DESIGN AND CONSTRUCTION MANUAL DESIGN MODIFICATION REQUEST

PROJECT NAME: Discovery Park Phase 1

PREMISE ADDRESS: NW Lee's Summit Rd & NE Douglas St.

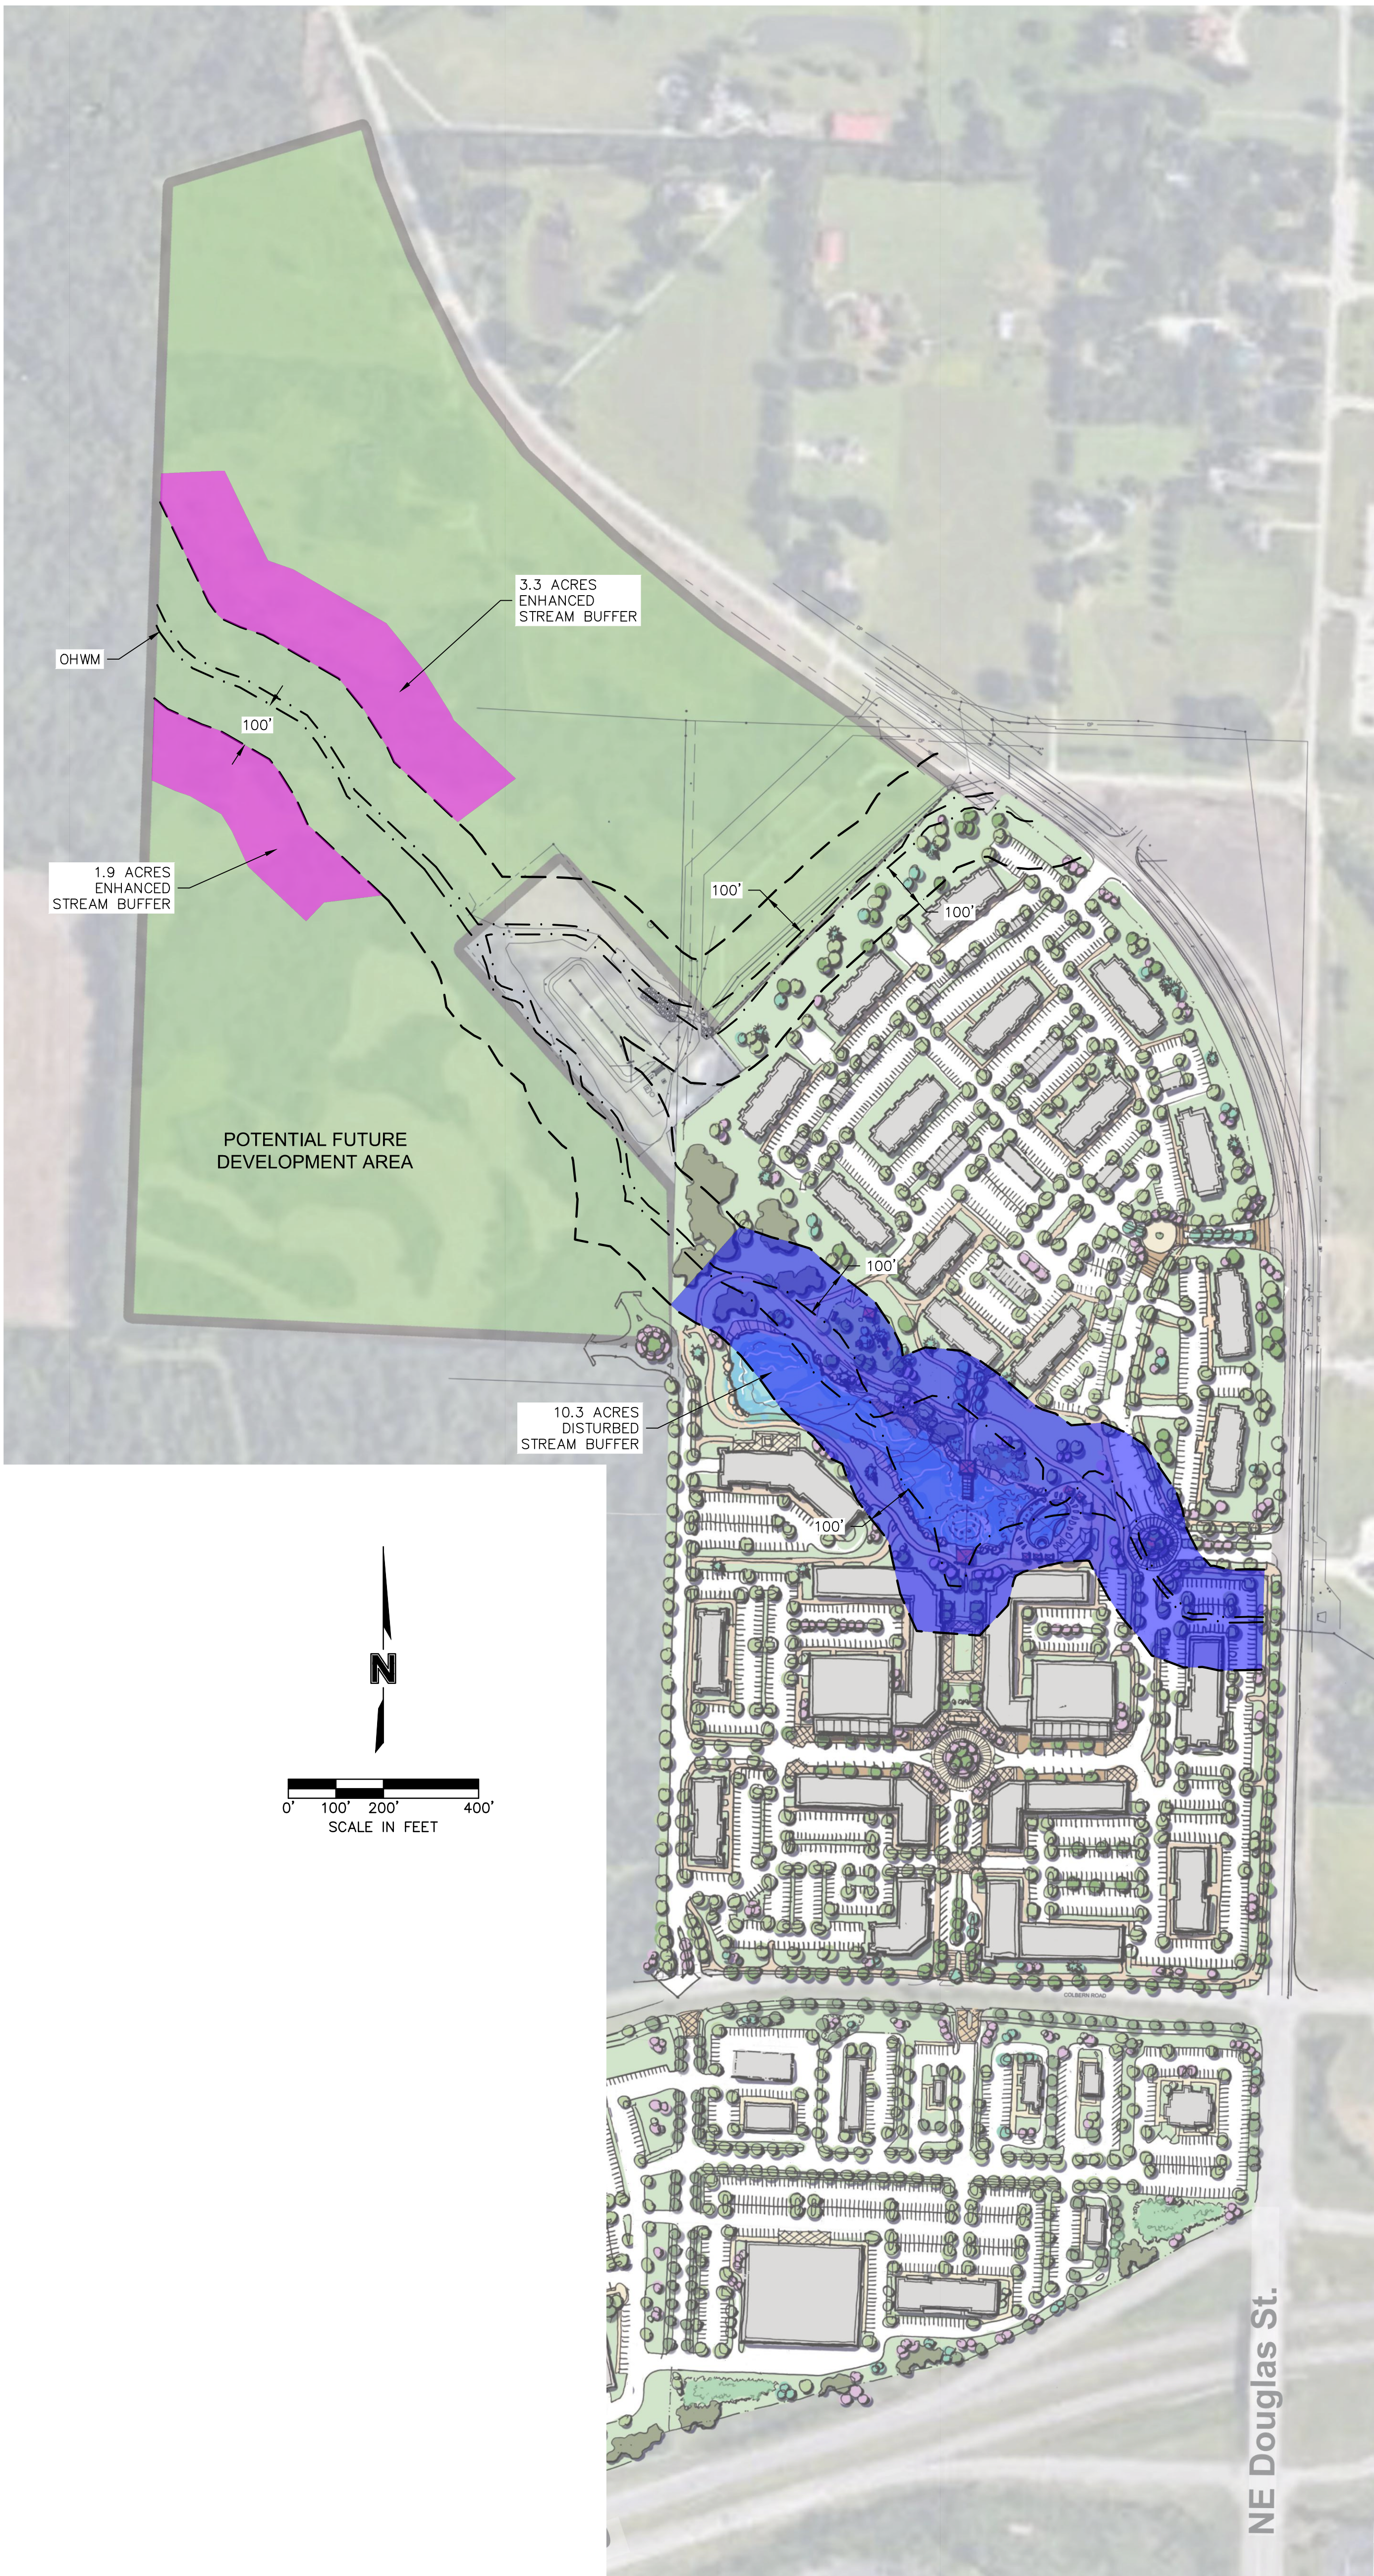
A waiver is being requested to remove 10.3 acres of stream buffer located within the project site (outlined in Section 5605 of KC-APWA Section 5600). This need to remove the existing creek channel, as shown on the attached exhibit, is driven by the site layout approved by the city TIF commission, which includes a wet-bottom detention basin that is part of a development amenity space with a pond, parkland, and walking trail. Additional improvements that impact the creek channel include required entrance drives, a clubhouse with swimming pool, and a hotel development lot. The upstream end of the existing creek channel begins at the outlet point of an existing concrete box culvert under NE Douglas Street. This box culvert will be extended approximately 1,560 linear feet to a point beyond the proposed improvements, discharged back into the creek channel, and armored to prevent any scour in the downstream channel. A permanent pool pond will be constructed in place of the creek channel and will be utilized for storm water rate and quality control.

In addition to the increased level of water quality treatment being provided for the development prior to discharging runoff into the creek, 5.2 acres of enhanced stream buffer is being proposed to be set aside downstream of the impacted creek channel to further offset any environmental/wildlife impact caused by removing stream buffer described.
